ADDENDUM # 2

Concerning the **"PSJA ISD AGRICULTURAL FACILITY PHASE I BID # 18-19-003"** to be opened at 4:00p.m., Thursday, OCTOBER 4, 2018. Please consider the following:

**ADDENDUM NUMBER TWO (2)
TO THE PLANS AND SPECIFICATIONS FOR:**

**PSJA Agricultural Facility – Phase I
PSJA ISD
Bid #
Project No. 16.08**

ADD. 2
A-302

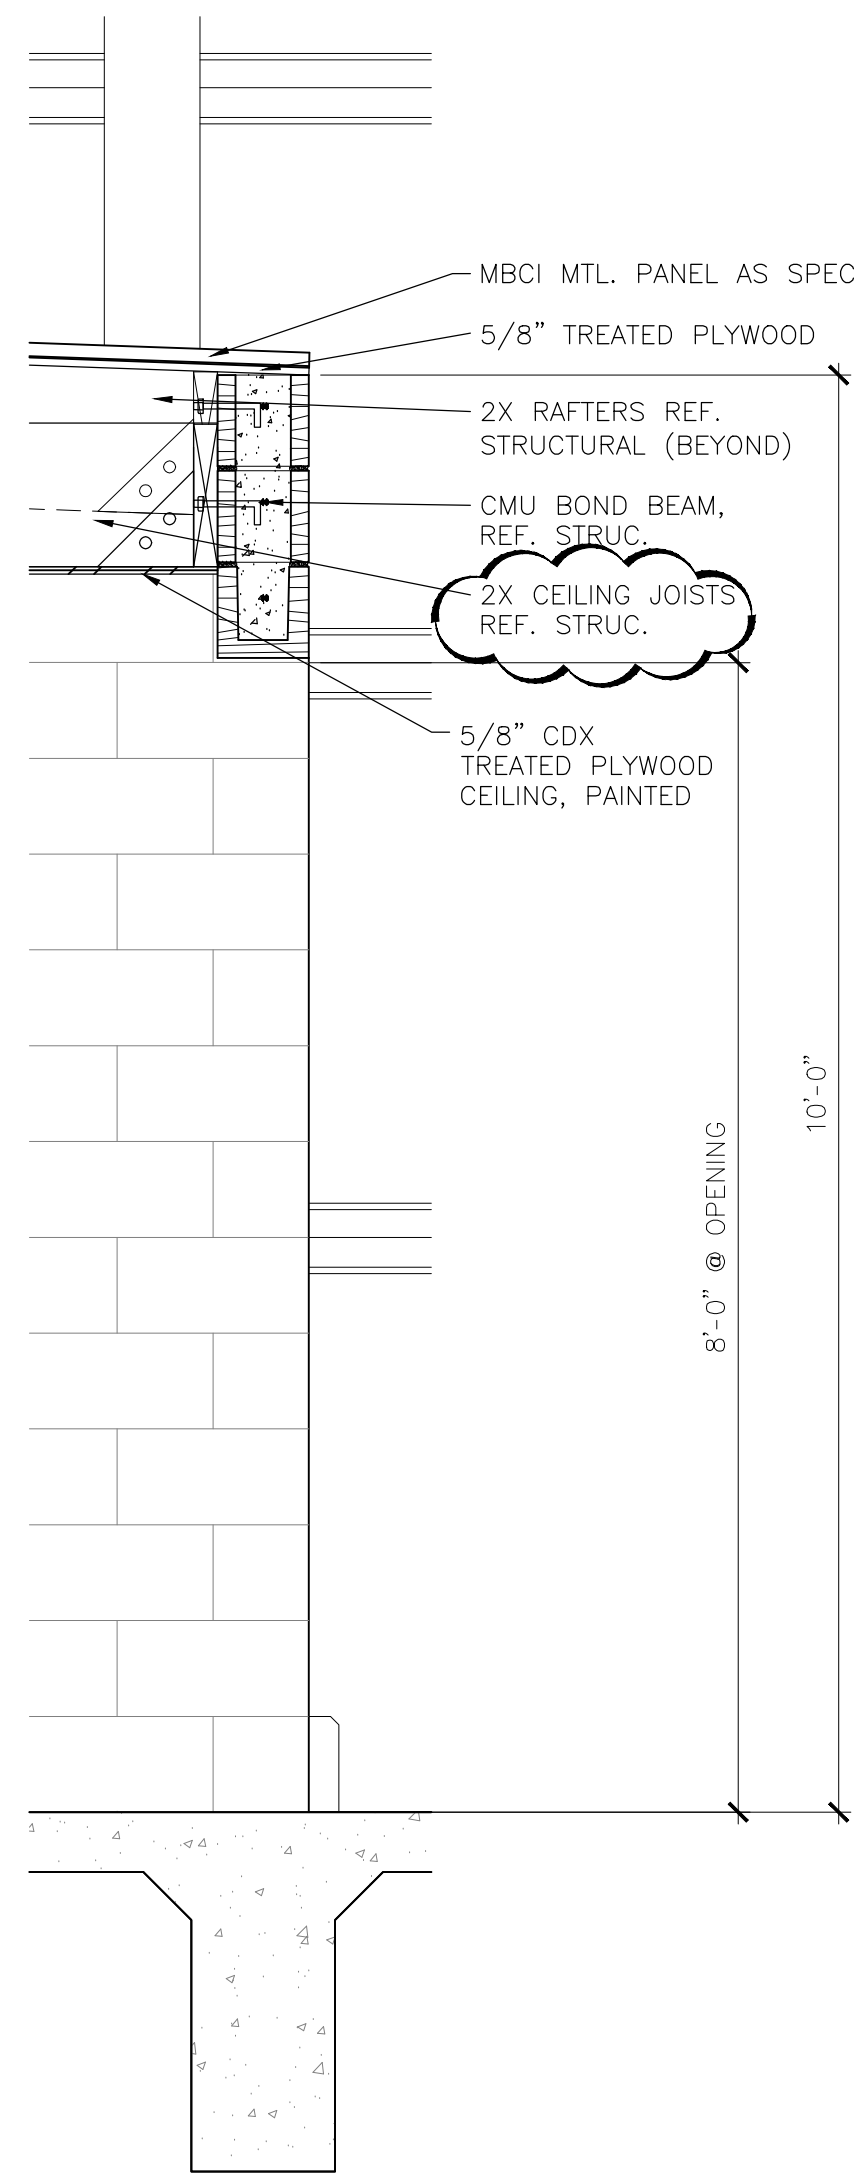
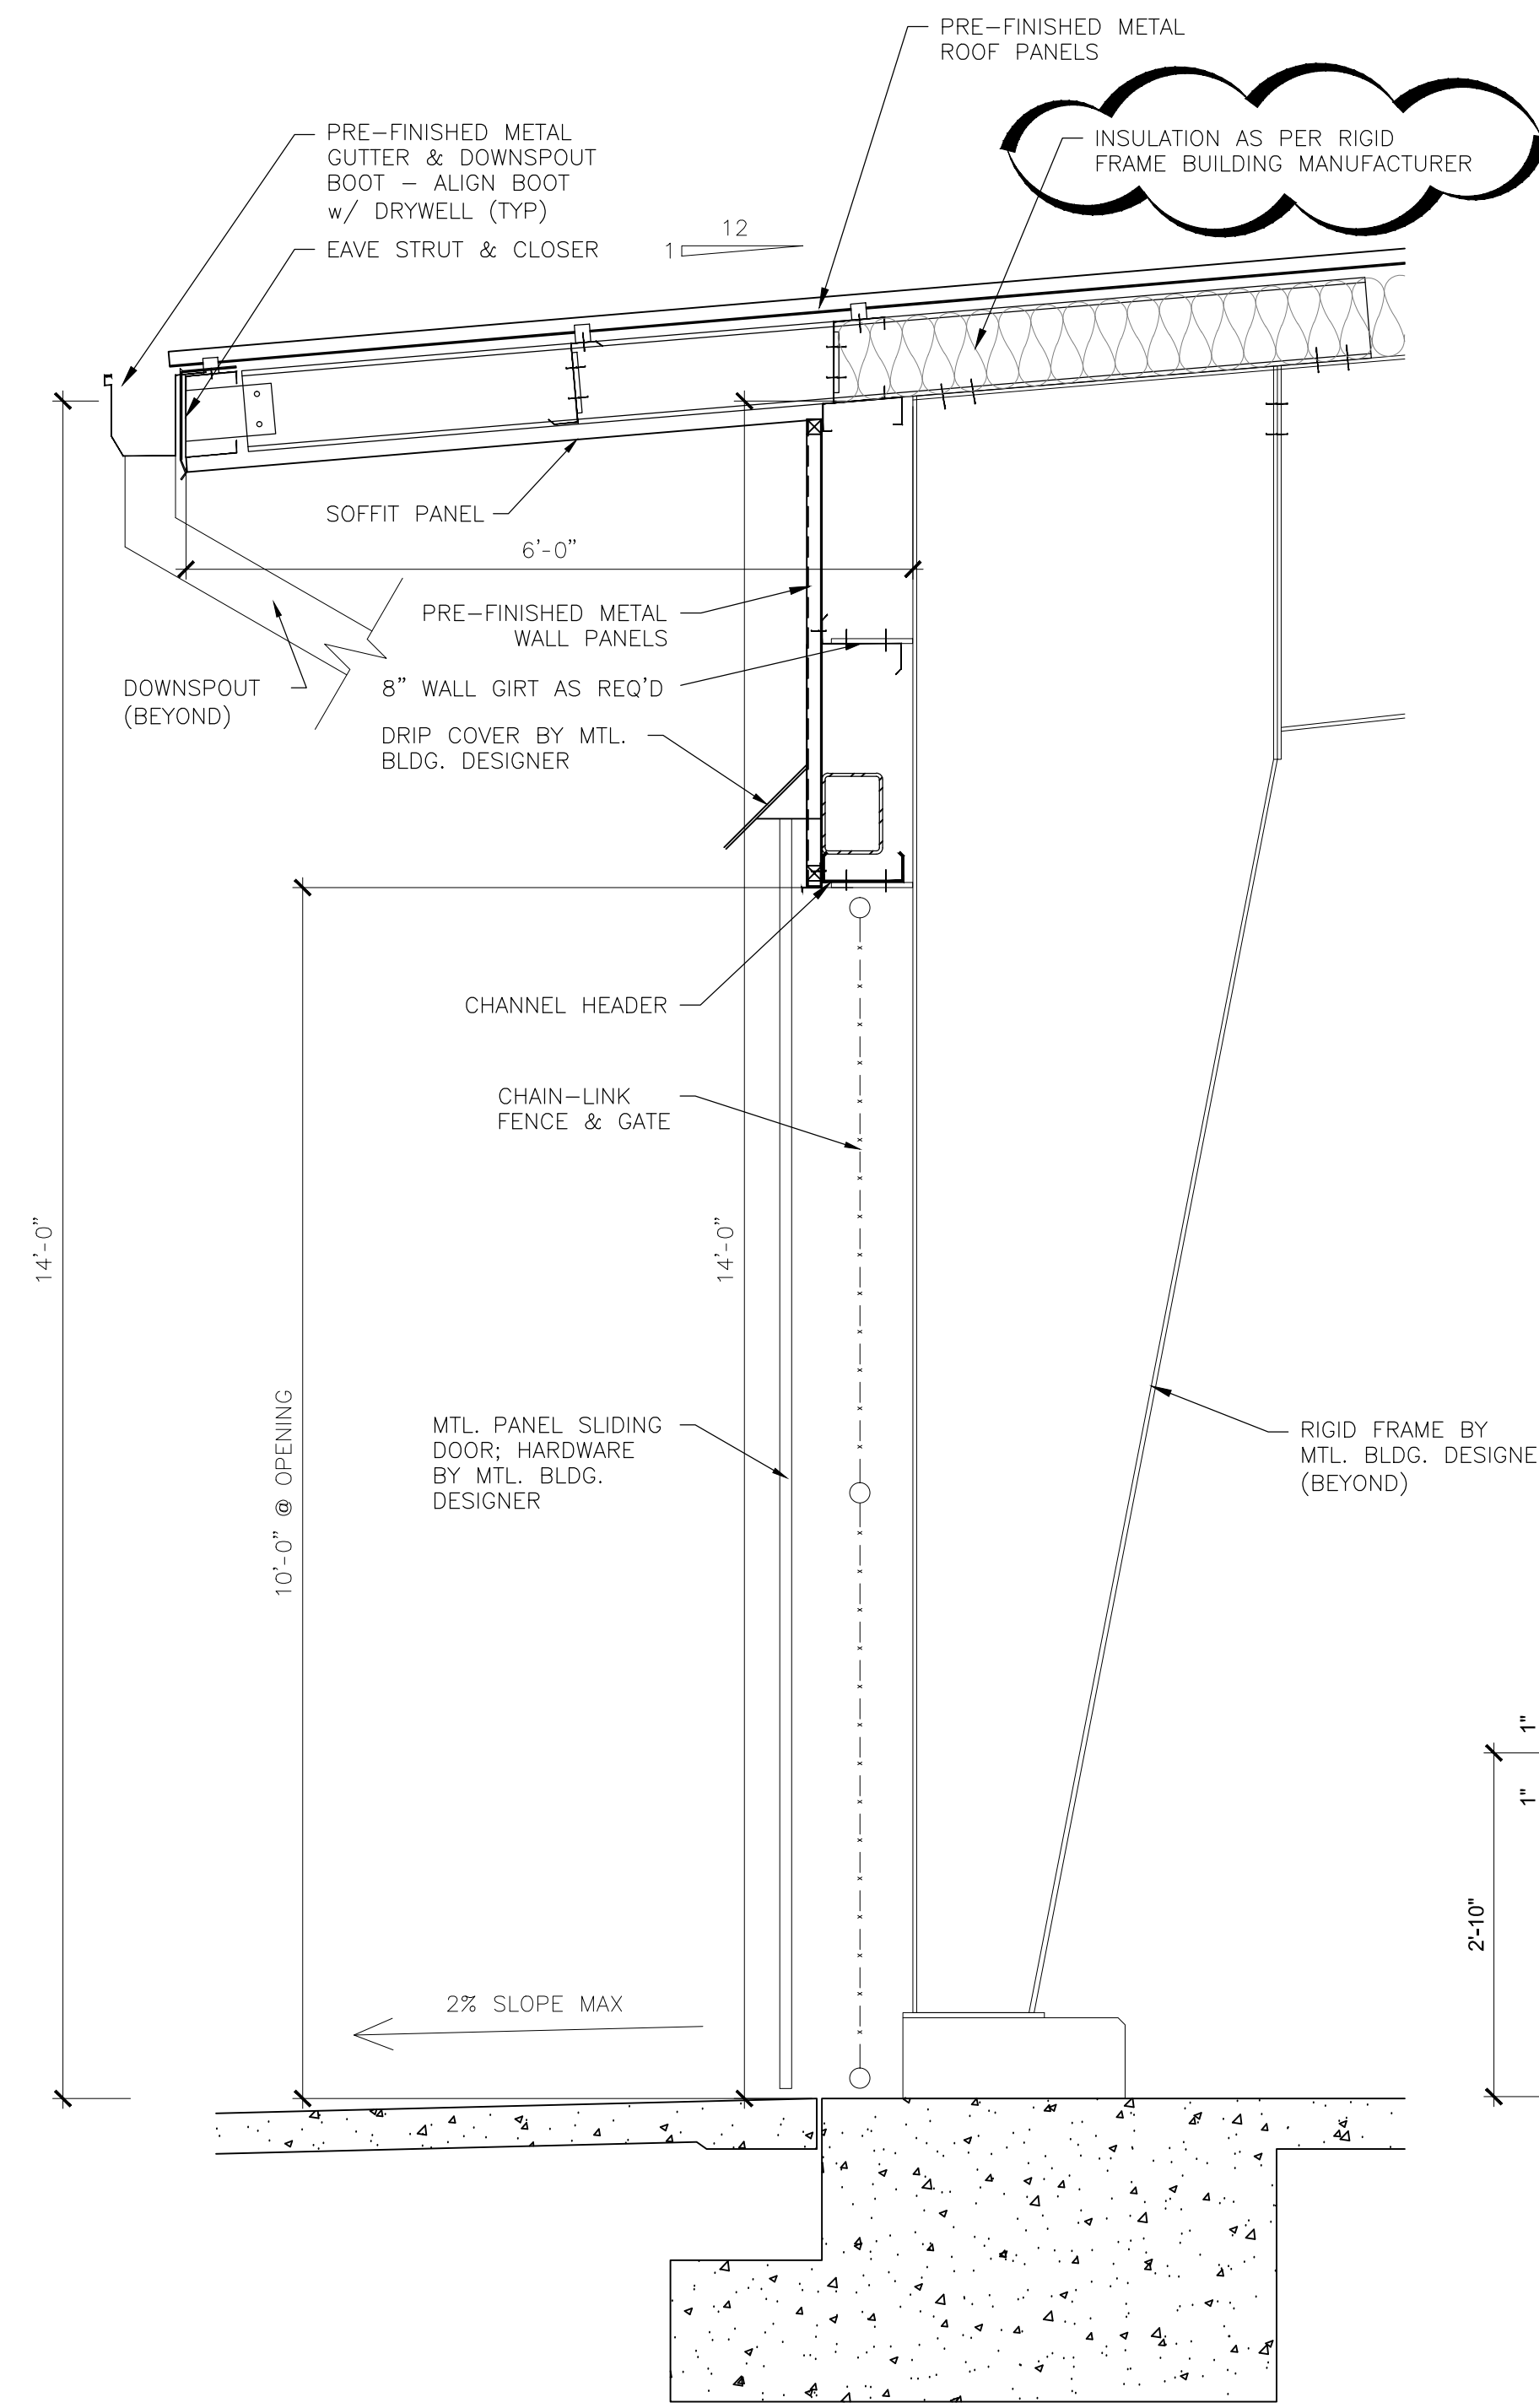
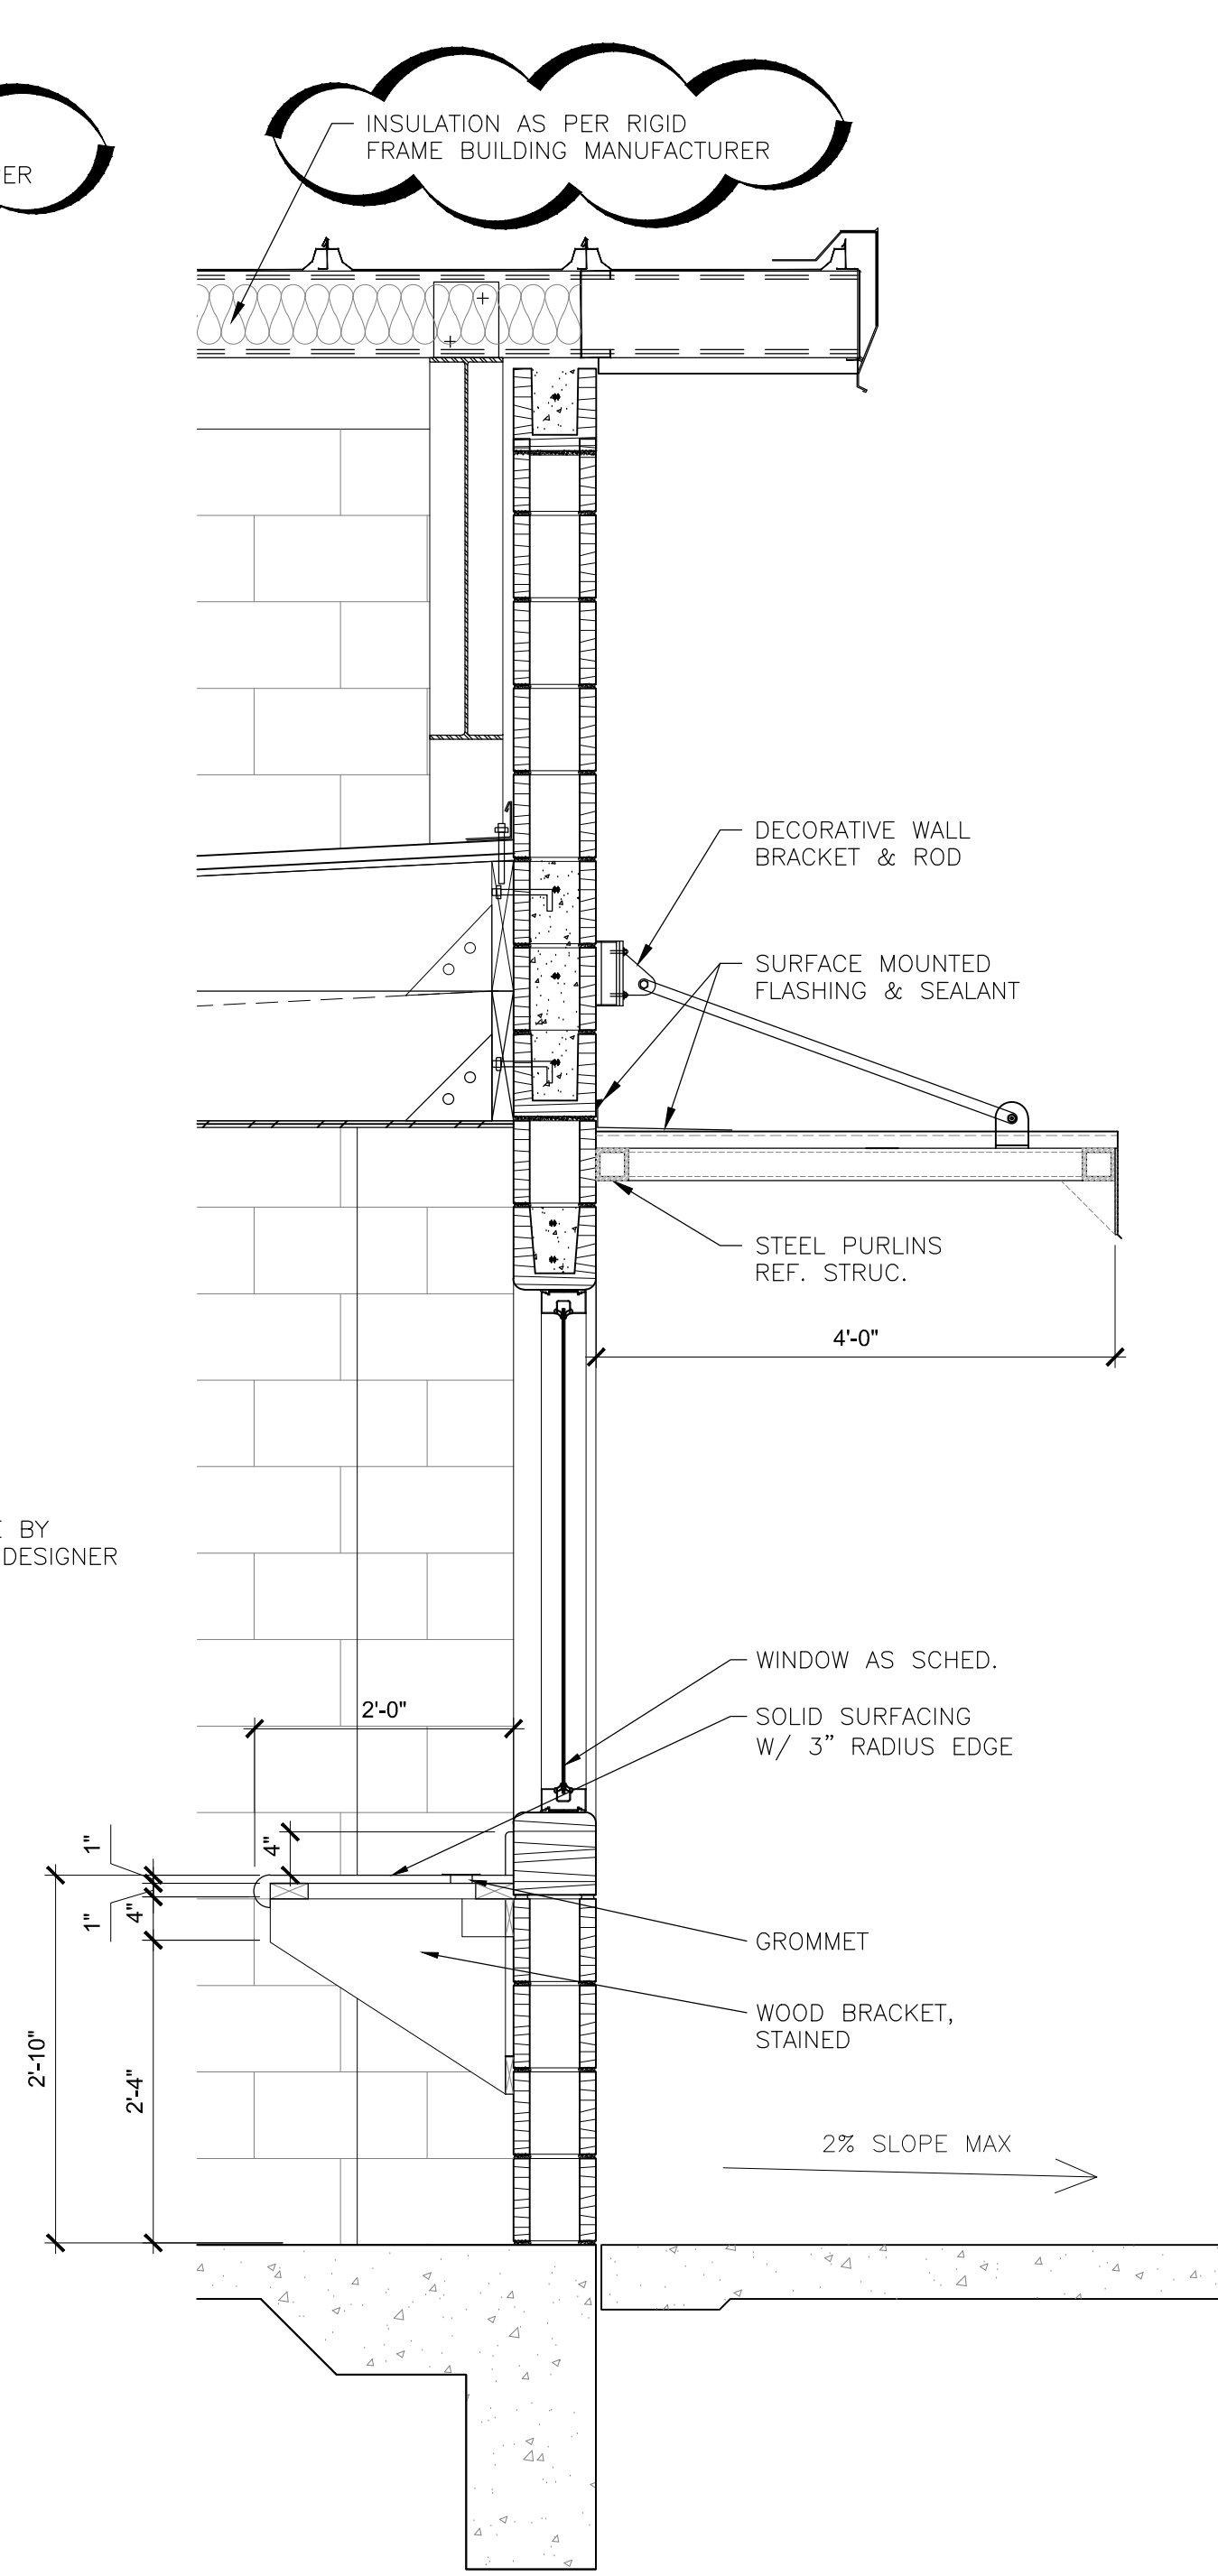
RFI: If the roof panel is not an insulated metal panel, please confirm the use of blanket insulation, thickness, and type (ie..banded system)

RFI: for architect or engineer. Architectural plan sheet A3.02 shows 2x12 wood studs, but on structural sheet S4.2 shows something different. Please verify/clarify.

Refer to reissued sheet A-301 & sheet A-302 for clarification.

Refer to reissued sheets A-301 & A-302 for clarification, detail now reads to refer to Structural.
